工程指示 / 要求簡箋 ENGINEER INSTRUCTIONS(E.I.)

工程指示編號:	EI- 9394	修改版本:	-
	HK- 0015		
工程編號:	J 861	工程名稱:	己連拿利
收件人:	生統/技術部	發件人:	細佬
工程項目:	幕牆施工圖更新	日期:	07/01/2026

PROJECT :
PROPOSED RESIDENTIAL DEVELOPMENT AT NOS. 3-6 GLENEALY, CENTRAL, HONG KONG

DWG NO. : J861-BD-CW-3005 REV. : A

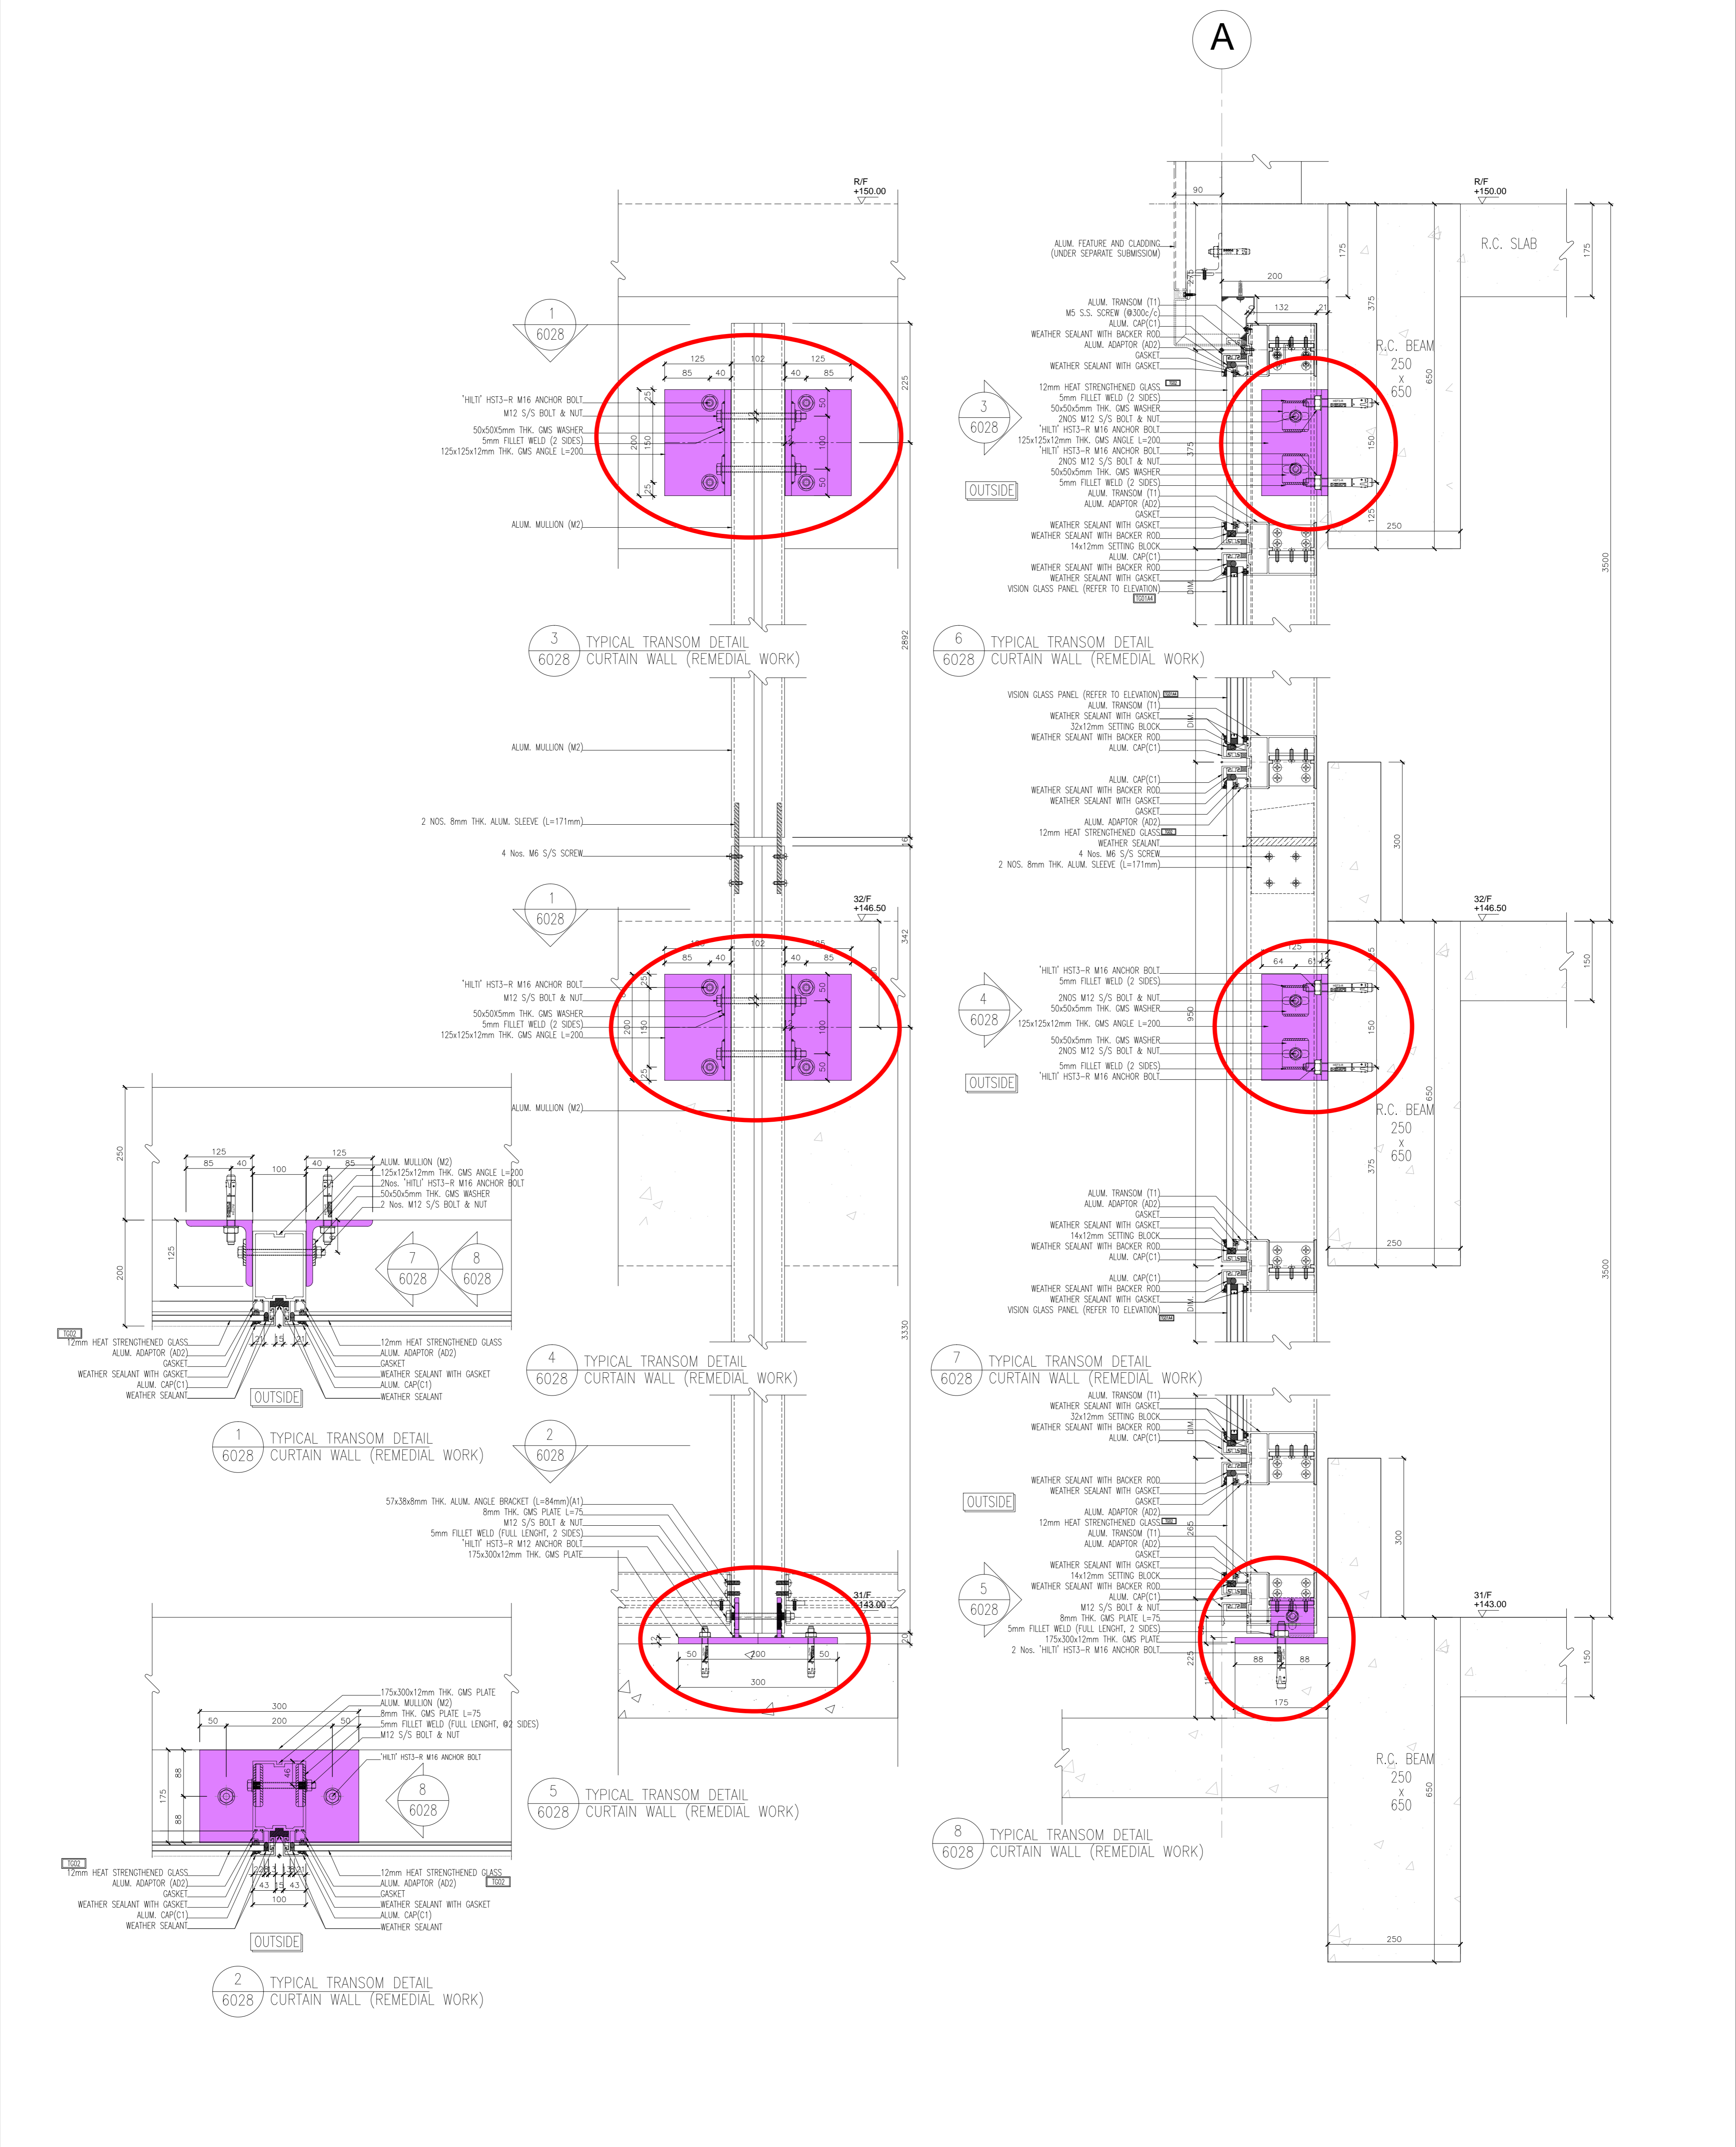
內容:	<p>給技術部: 31和32樓幕牆要打拉爆螺絲的修補方案(請看附頁資料紅圈的位置), 請製作相關的鐵件加工圖。</p> <p>另外圖號: 6008的趟門頂要鐵角設計有改, 需要重新訂料和製作加工圖(紅色圈內的鐵角, 只影響SD-04和SD-04R)</p> <p>備注: 1月6日大明通知</p> <p>CAD文件在以下位置</p> <p>J:\midi_sharepoint\Public\to_china\謝永林\J861\EI9394_HK0015_CAD</p>
完成上列要求日期:	15/01/2026

DATE : 6-SEP.-24	SCALE : 1:2 (A1)
DRAWN BY : Asing	CHECKED BY :
DWG NO. : J861-BD-CW-6008	REV. : A

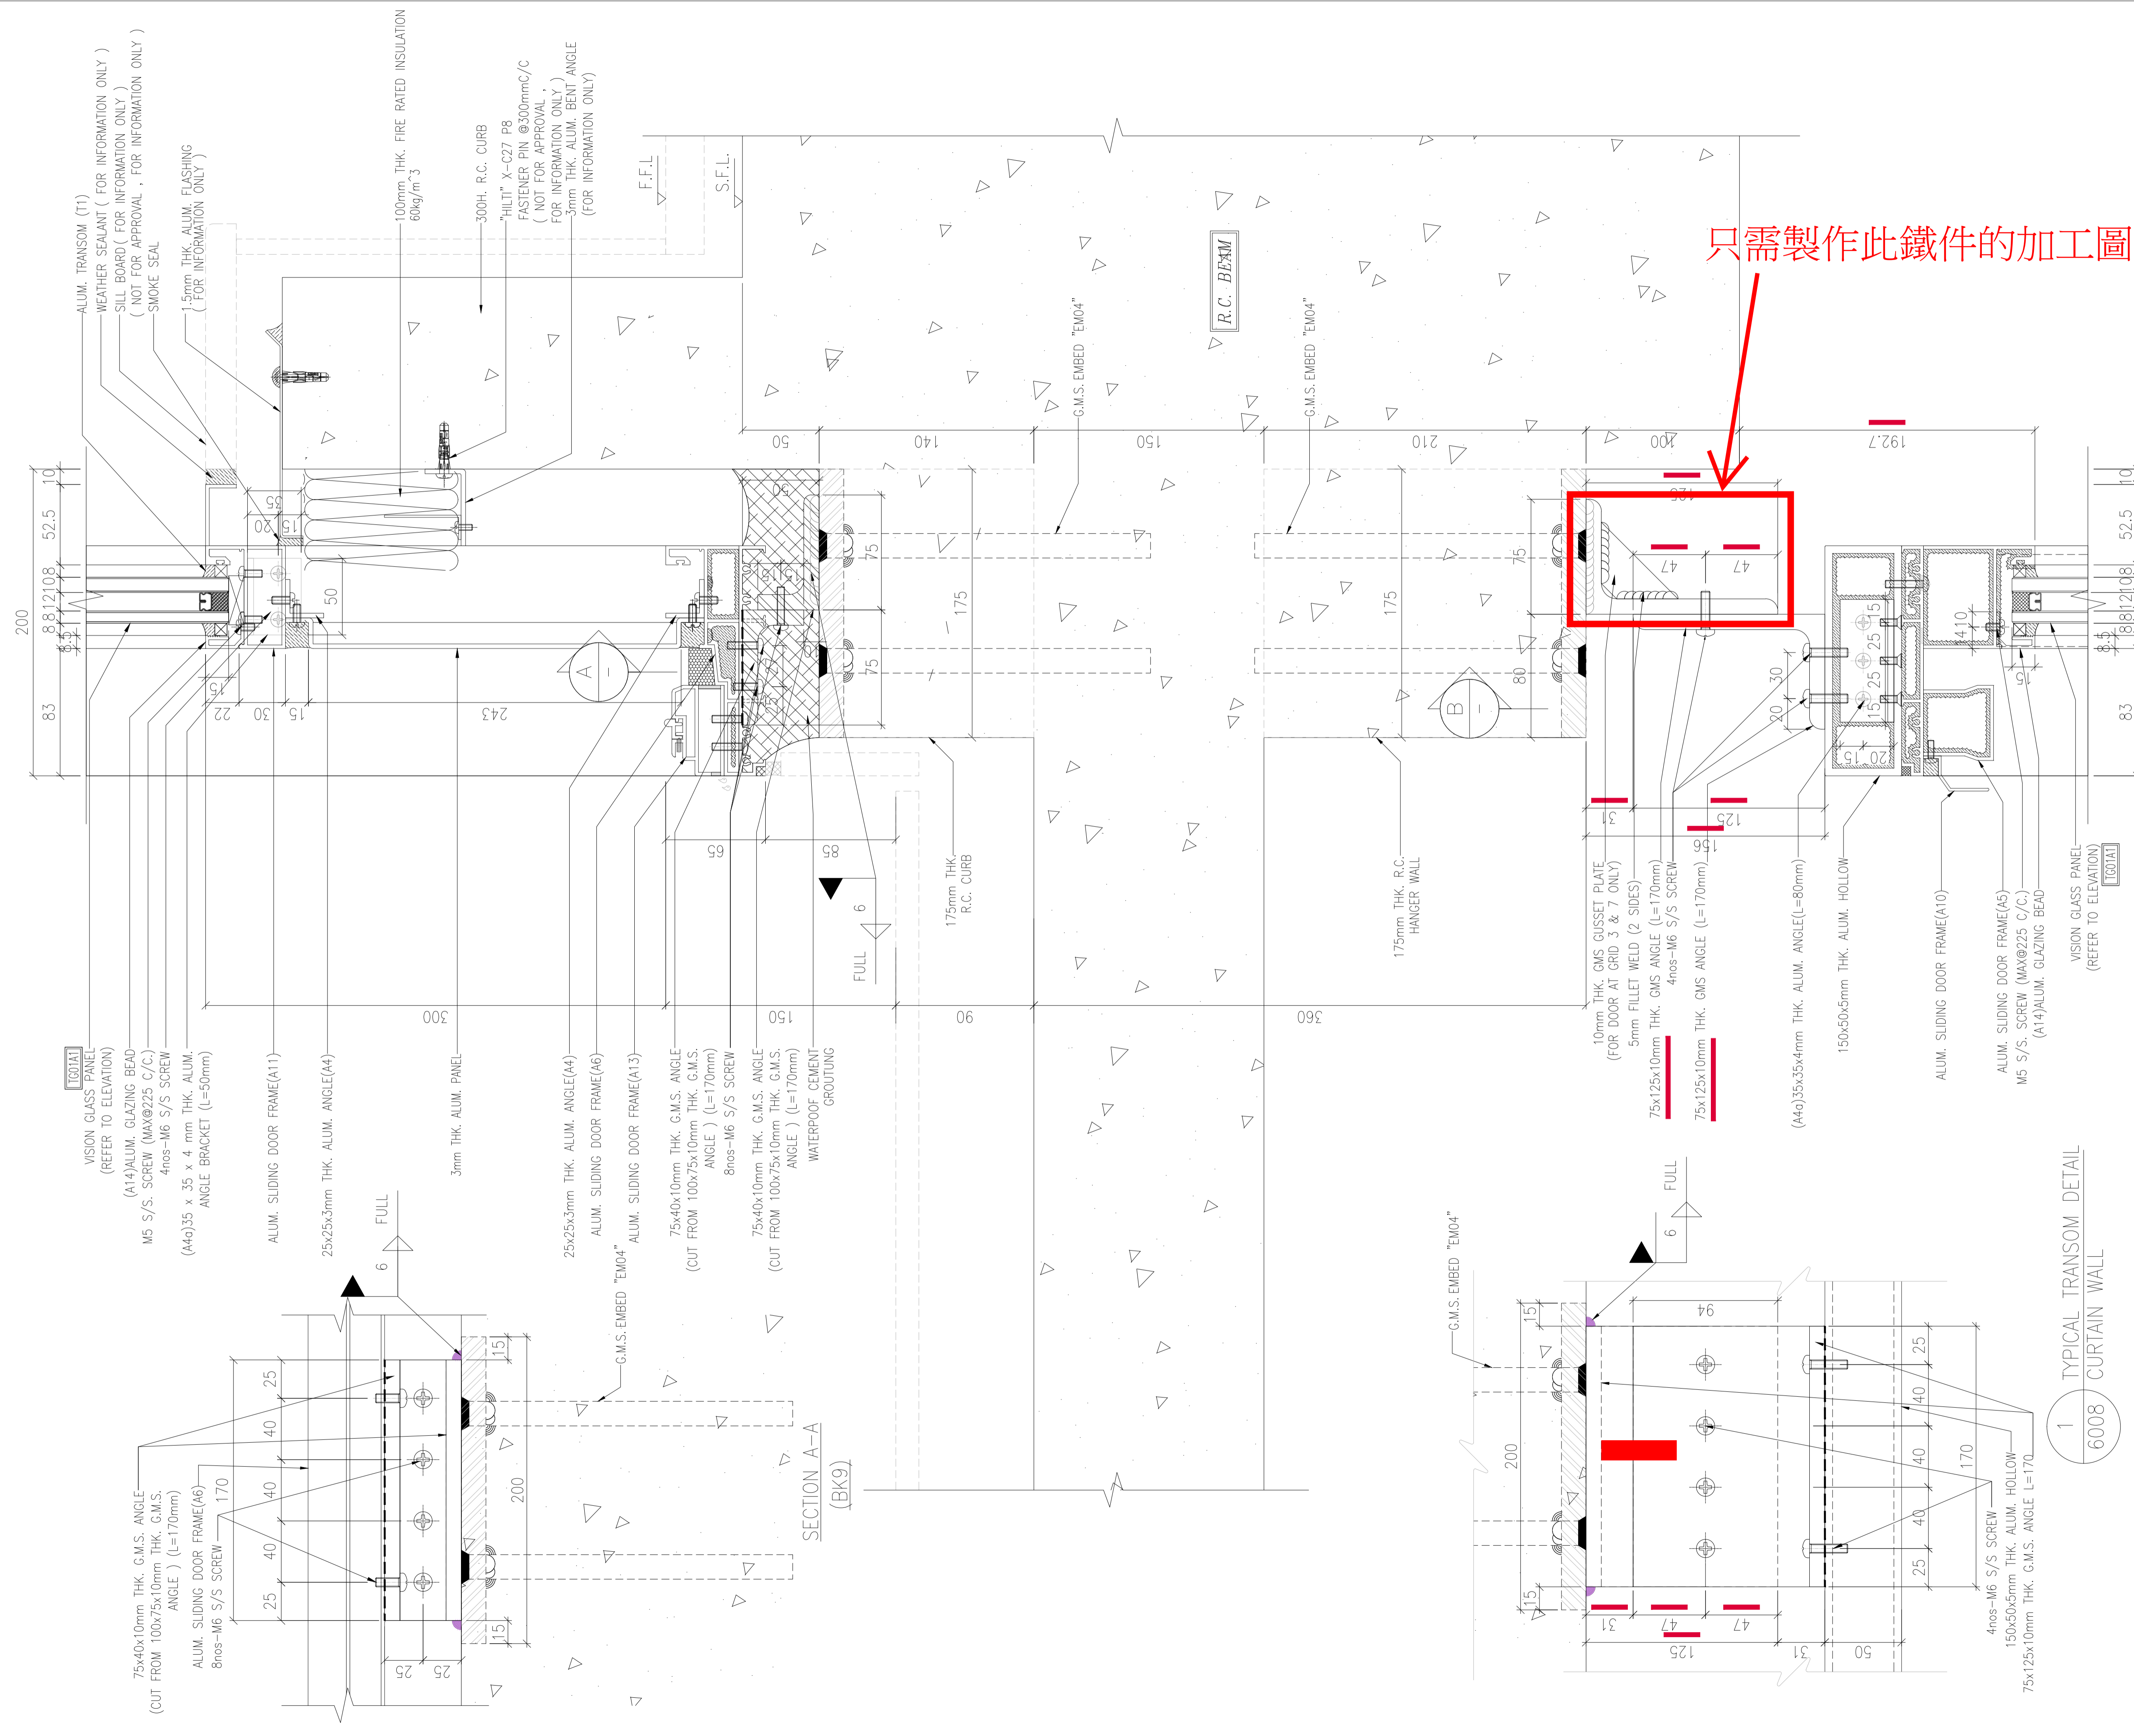
只需製作此鐵件的加工圖
